MARKET ANCILLARY SERVICES SPECIFICATION CONSULTATION - COMMENCED SEPTEMBER 2009 - FINAL DETERMINATION AND REPORT

PREPARED BY: Electrical System Operations Planning and Performance

ISSUE DATE: 07 May 2010

FIGURE 1 – COMPENSATION FOR CHANGE IN DISPATCH

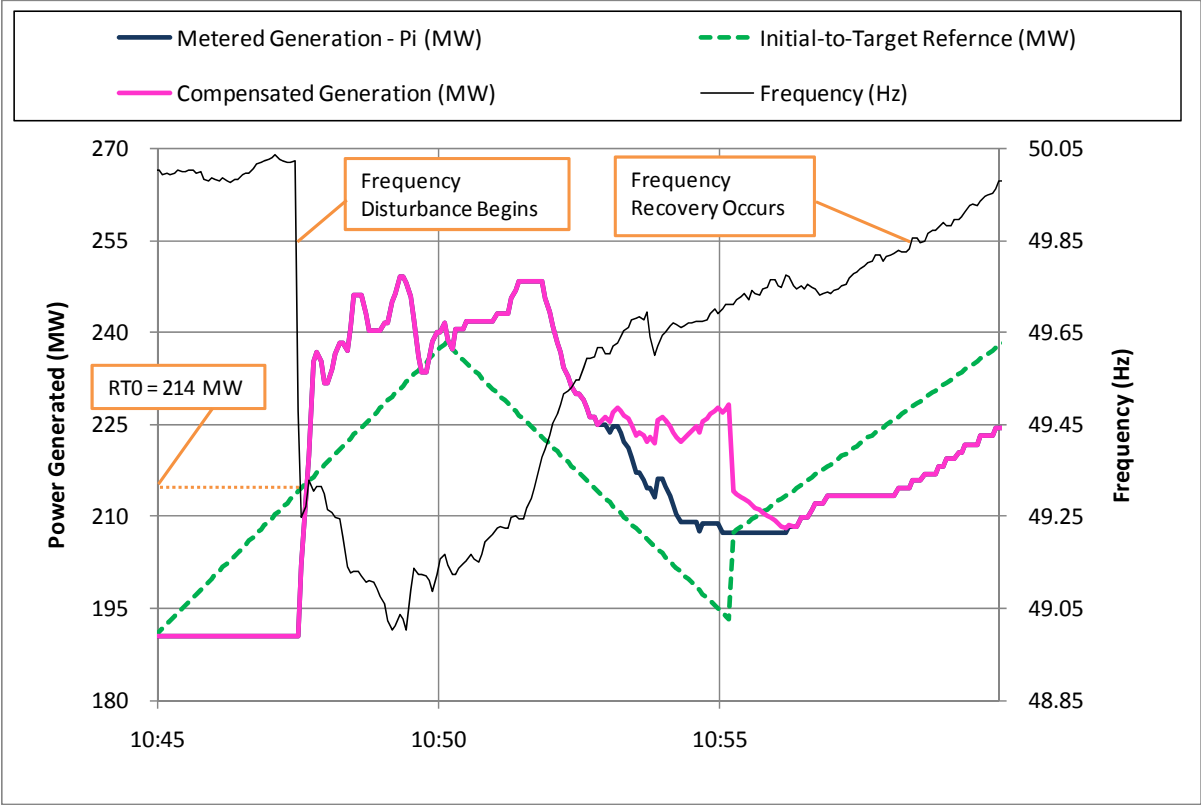
Figure 1 shows the compensation method being applied to an *ancillary services generating unit* supplying *delayed raise service* following a *low frequency event*⁴. Dispatch targets for dispatch intervals 10:50, 10:55 and 11:00 are 240, 192 and 240 MW respectively. The frequency excursion begins in the 10:50 dispatch interval and recovery occurs in the 11:00 dispatch interval. In the 10:55 dispatch interval the unit receives a dispatch target below the value of its reference trajectory at the time of the frequency disturbance. As can be seen the compensation process works to negate the negative impact of dispatch (the decreasing dispatch target in DI 10:55) process whilst not adding additional compensation for the positive impact of the dispatch process (the increasing dispatch targets in DI 10:50 and 10:55).

FIGURE 2 – DISPATCH COMPENSATION DERIVED FROM EXAMPLE SHOWN IN FIGURE 1

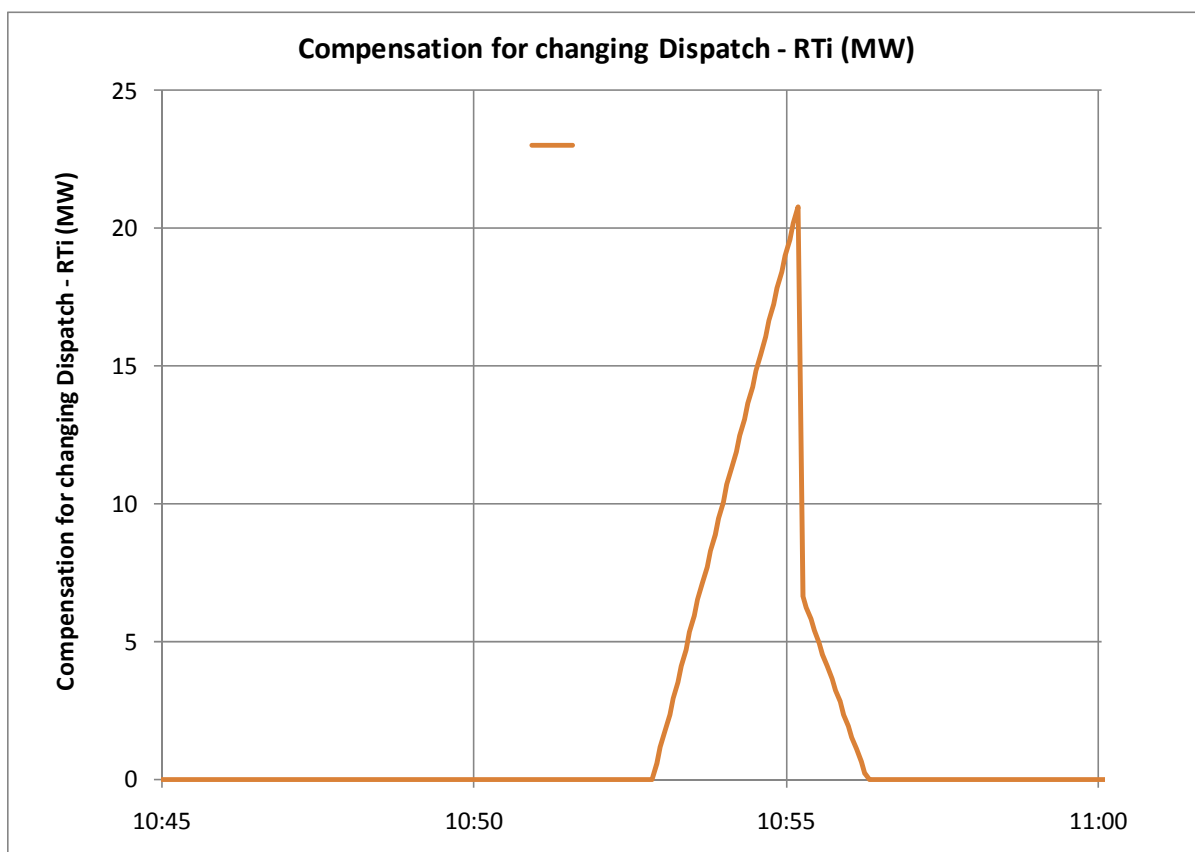
It should also be noted that the unit is not penalised for deviating from its reference trajectory in the 10:50 dispatch interval, this is shown explicitly in Figure 2.
